NUMBER: 23-040-15

Right Sliding Door Will Not Open From Exterior

This bulletin involves replacing the right sliding door exterior handle and rerouting door cable.

2014 - 2015 (VF) Ram Pro Master

Fig. 3 Door handle nuts

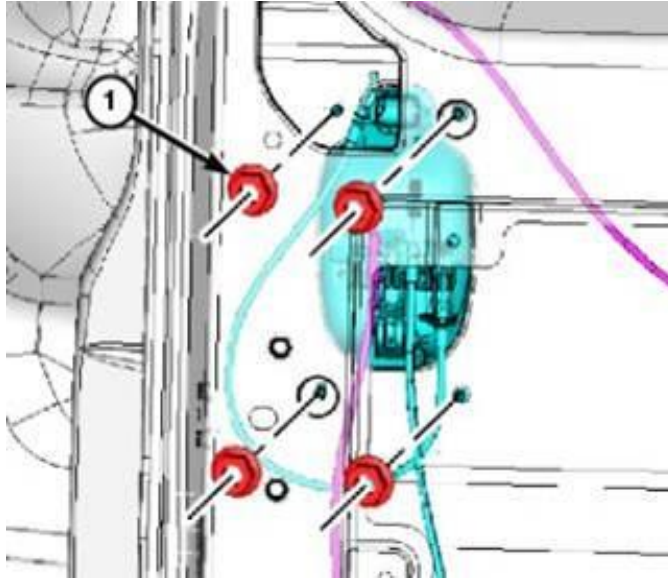
5. Remove four mounting nuts (1) to outer handle ([Fig. 3](#)).

21. Install the handle to the vehicle and engage cable at interior handle (Fig. 6).
22. Install the four mounting nuts (1) to outer handle (Fig. 3). Tighten to 9 N·m (80 in.lbs).
23. Install the interior door handle. (Refer to 23 - Body/Doors - Sliding/HANDLE, Interior/Installation) (Fig. 2).
24. Install rubber bump stop (Fig. 1). Tighten to 25 N·m (221 in.lbs).
25. Install the trim panel. (Refer to 23 - Body/Doors - Sliding/PANEL, Door Trim/Installation).
